8073 – Tonquin Employment Area Sanitary Upgrade

DATE: March 29, 2013

ADDENDUM NO. 1

Addition/Change to the Contract Documents

**SANITARY SEWER
PLAN AND PROFILE
SOUTHWEST**

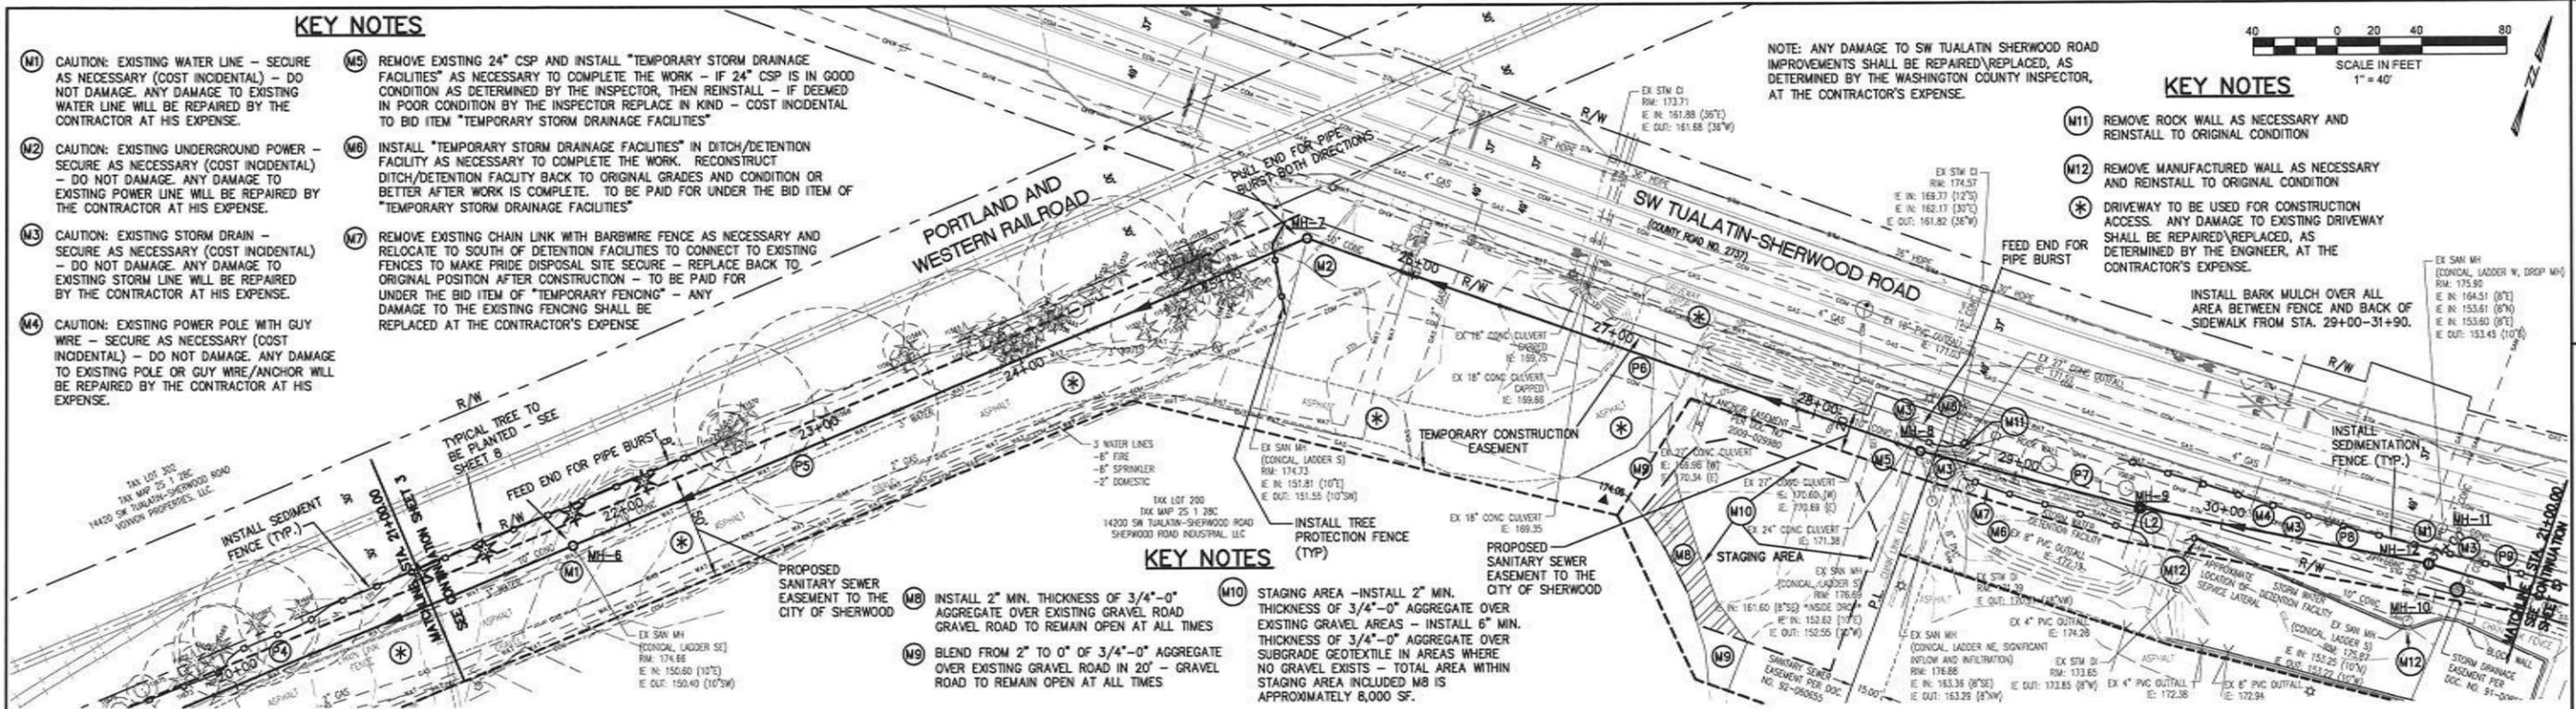
6. The existing pipe flow in sanitary sewer west of MH-10 is approximately 0.50 CFS.
7. Bid Schedule Item #21 shall be changed from "15-Inch, PVC, C-905 Pipe" to "16-Inch, PVC, C-905, DR 18 Pipe". All references to "15-Inch, PVC, C-905 Pipe" in the Special Provisions and on the Contract Drawings shall be changed to "16-Inch, PVC, C-905, DR 18 Pipe".

15.75" I.D. (PIPE BURST)
L=315.27' S=0.35%
- (P4)** INSTALL 16" PVC C905, DR18
(OPEN TRENCH)
L=299.80' S=0.35%
- (L1)** INSTALL 8" PVC D3034, SDR 35
L=±20' S=2.0% MIN.
+ TWO 8" 45° BENDS
+ 8" WYE + 8" C.O. TO F.G.
ONCE NEW PIPING HAS BEEN
TESTED AND APPROVED, CONNECT
TO EXISTING SANITARY LATERAL
WITH FERRO - TO BE PAID
UNDER BID ITEM "RECONNECT
EXISTING SEWER LATERAL"

SANITARY SEWER PLAN AND PROFILE WEST T-S ROAD

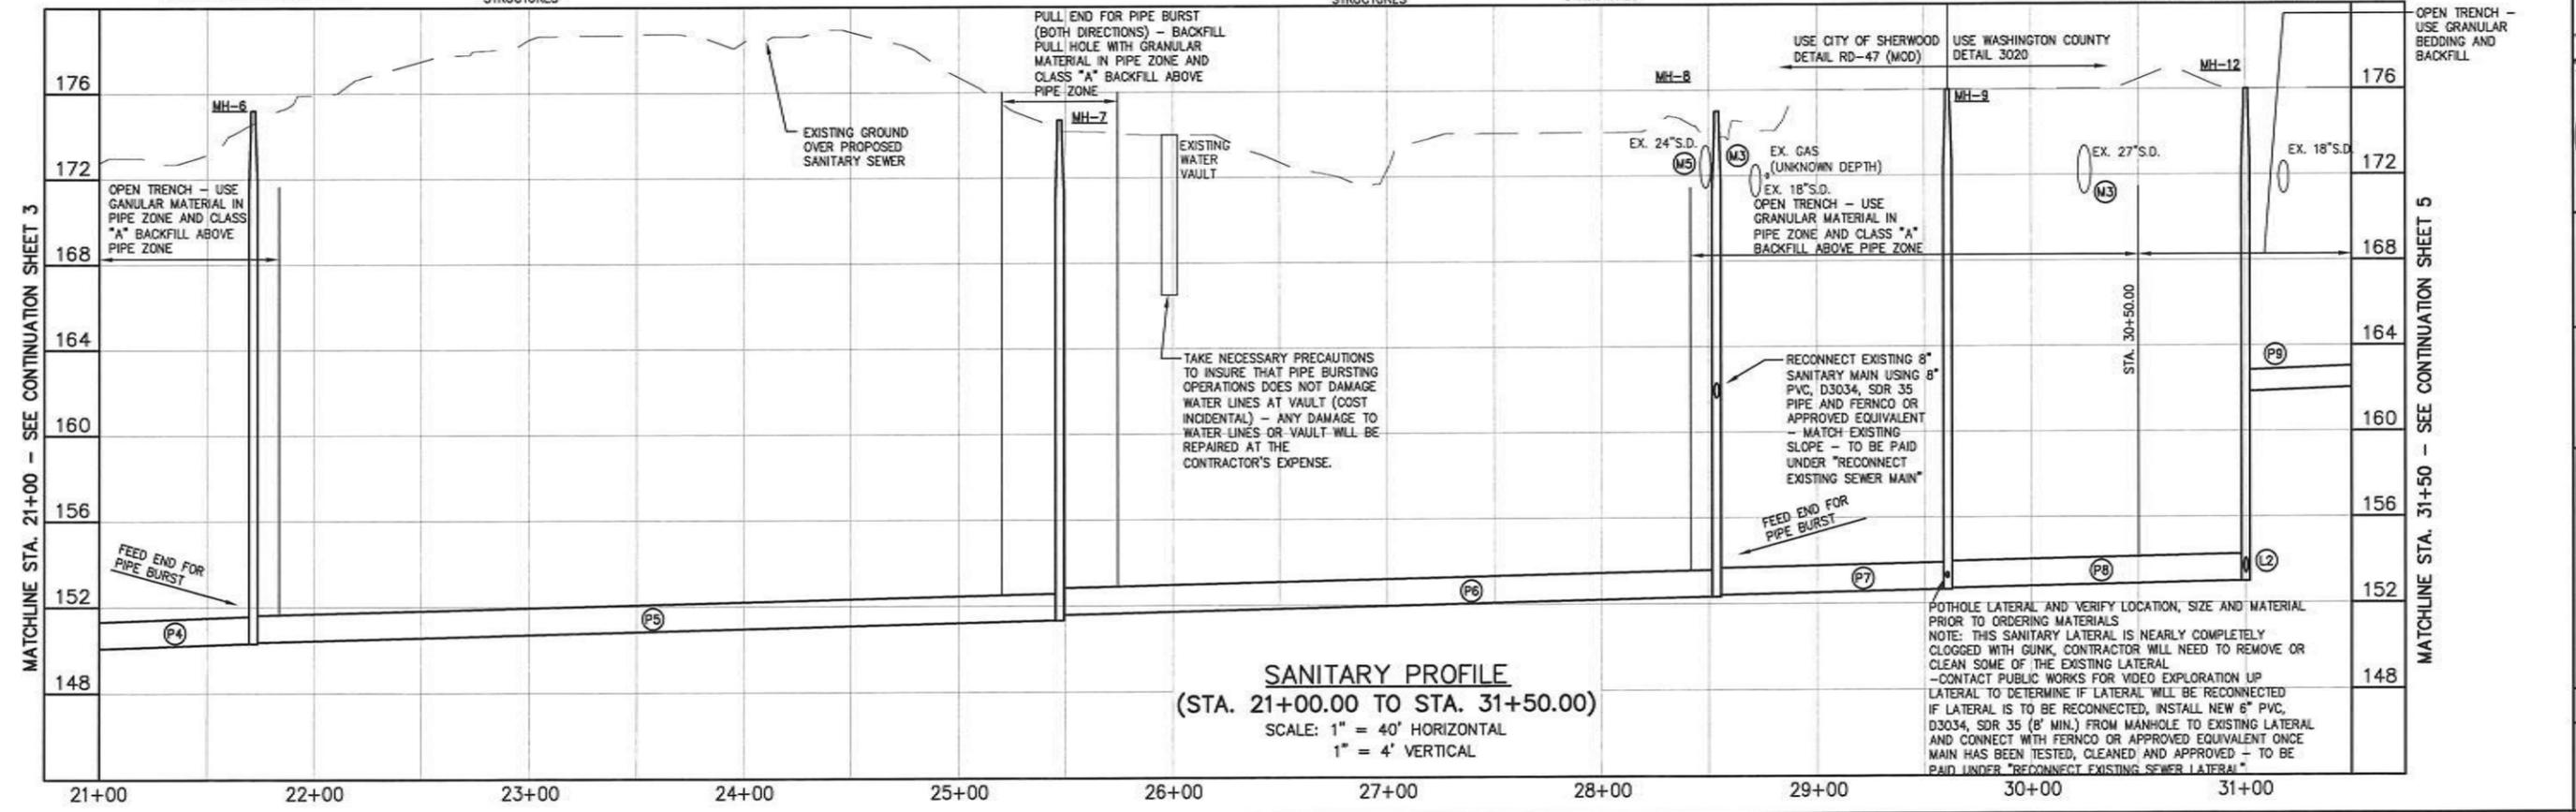
8. The contractor has the option to use pipe bursting methods for pipe P4 in place of the open trenching method identified within the Contract Drawings. For bidding and payment purposes pipe P4 is included in Bid Schedule Item #21 – "16-Inch, PVC, C-905, DR 18 Pipe" and will be paid at the unit price for this Bid Item no matter which method the contractor selects for the installation of pipe P4. If selected, pipe bursting shall use an 18-Inch OD HDPE DR 17 pipe and be installed in compliance with the Special Provisions.

- (P4) INSTALL 16" PVC C905, DR18 (OPEN TRENCH)
L=299.80' S=0.35%
- (P5) INSTALL 18" O.D. HDPE DR17 15.75" I.D. (PIPE BURST)
L=371.45' S=0.28%
- (P6) INSTALL 18" O.D. HDPE DR17 15.75" I.D. (PIPE BURST)
L=302.31' S=0.24%
- (P7) INSTALL 16" PVC C905, DR18 (OPEN TRENCH)
L=103.36' S=0.23%

- (P8) INSTALL 16" PVC C905, DR18 (OPEN TRENCH)
L=135.29' S=0.23%
- (P9) INSTALL 12" PVC D3034, SDR 35 (OPEN TRENCH)
L=192.74' S=0.40%
- (L2) INSTALL 8" PVC D3034, SDR 35 L=5' S=MATCH EXISTING SLOPE ONCE NEW PIPING HAS BEEN TESTED AND APPROVED, CONNECT TO EXISTING SANITARY LATERAL WITH FERNCO - TO BE PAID UNDER BID ITEM "RECONNECT EXISTING SEWER MAIN"

ACCESS ROAD PLAN

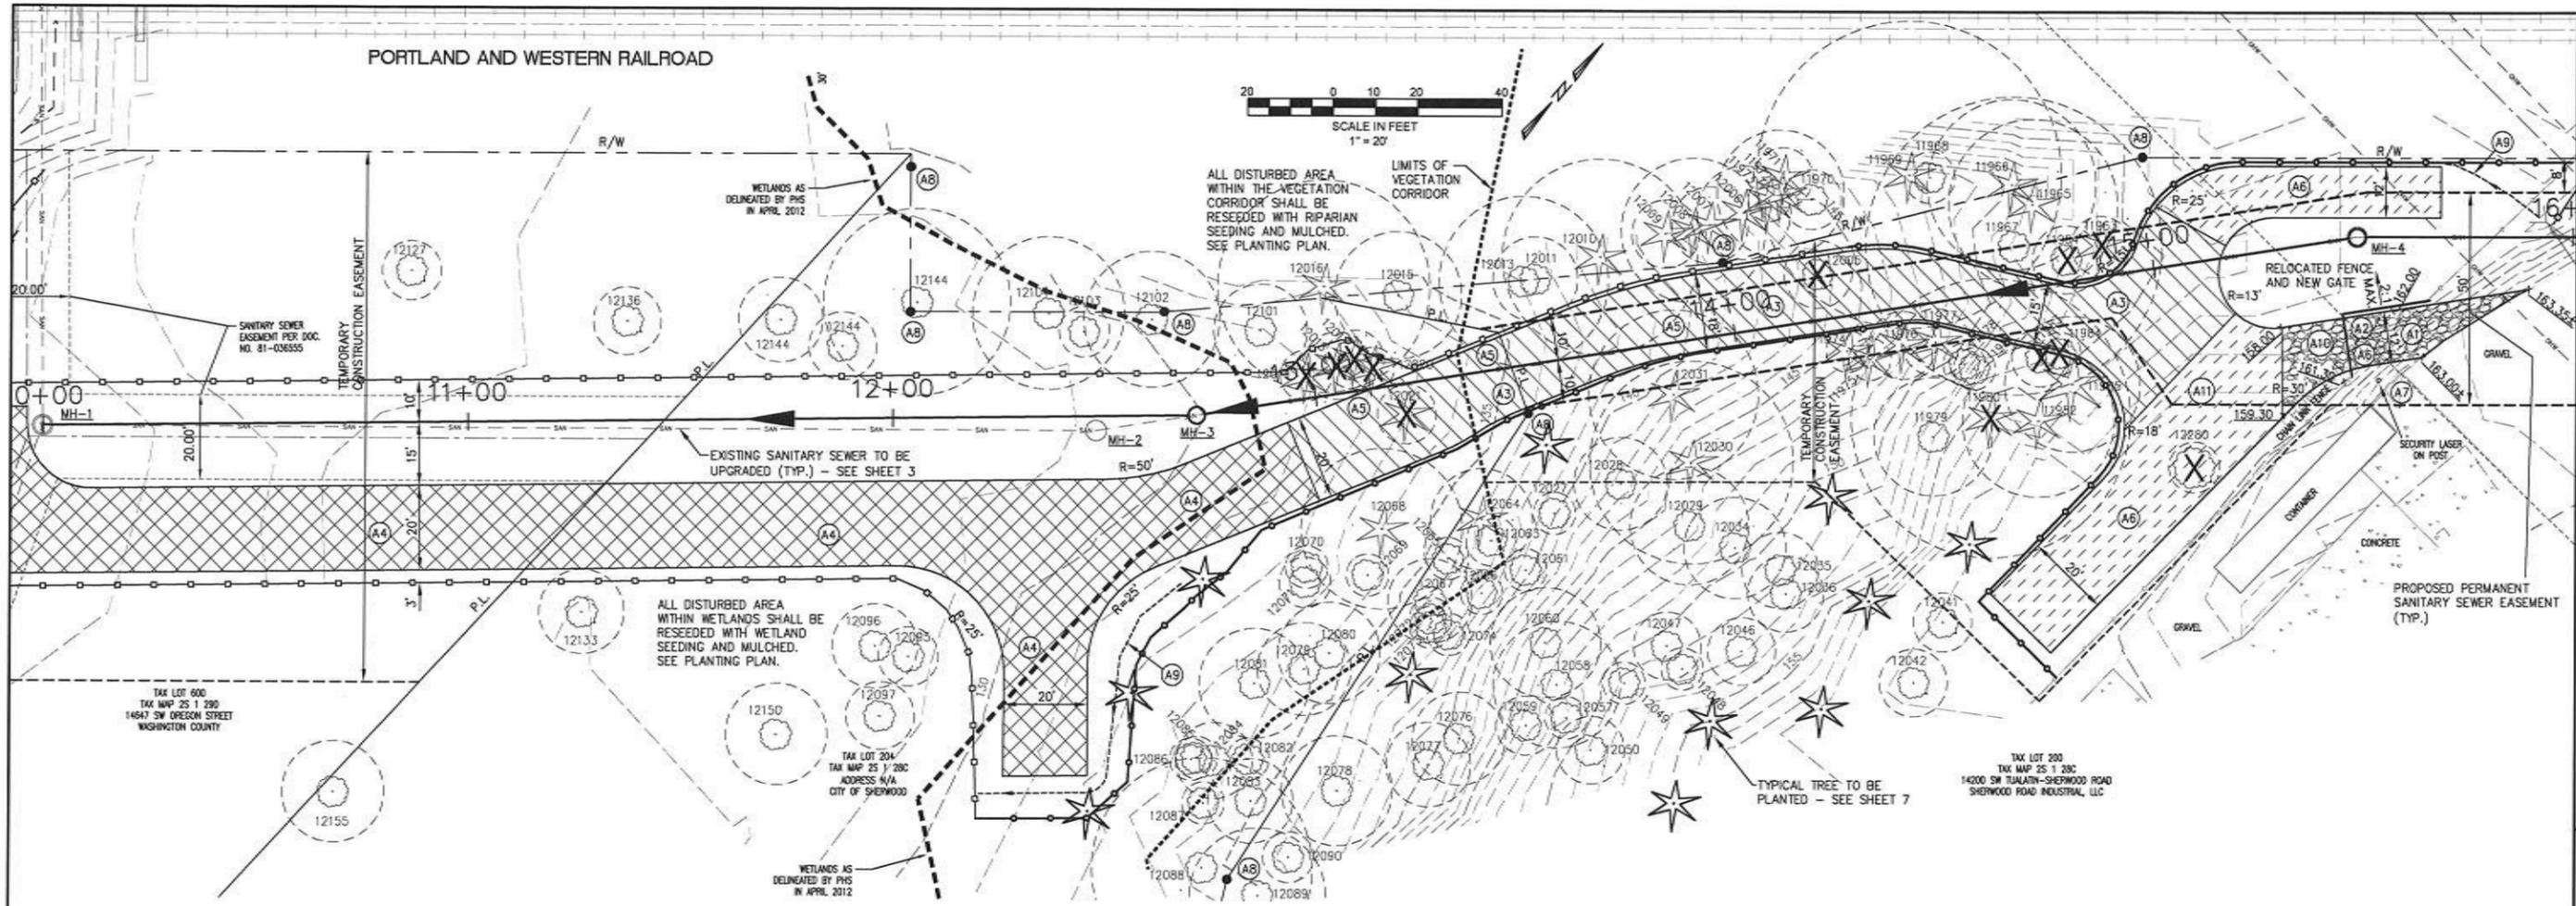
5. Fuel, hazardous material or any equipment containing fuel or hazardous material shall be located within the staging area at the end of each day with the exception of pipe bursting equipment installed within pull pits. All fueling or greasing of equipment shall occur inside the staging area.

NOTE: FUEL, HAZARDOUS MATERIAL OR ANY EQUIPMENT CONTAINING FUEL OR HAZARDOUS MATERIAL SHALL BE LOCATED WITHIN THE STAGING AREA AT THE END OF EACH DAY WITH THE EXCEPTION OF PIPE BURSTING EQUIPMENT INSTALLED WITHIN PULL PITS. ALL FUELING OR GREASING OF EQUIPMENT SHALL OCCUR INSIDE THE STAGING AREA.
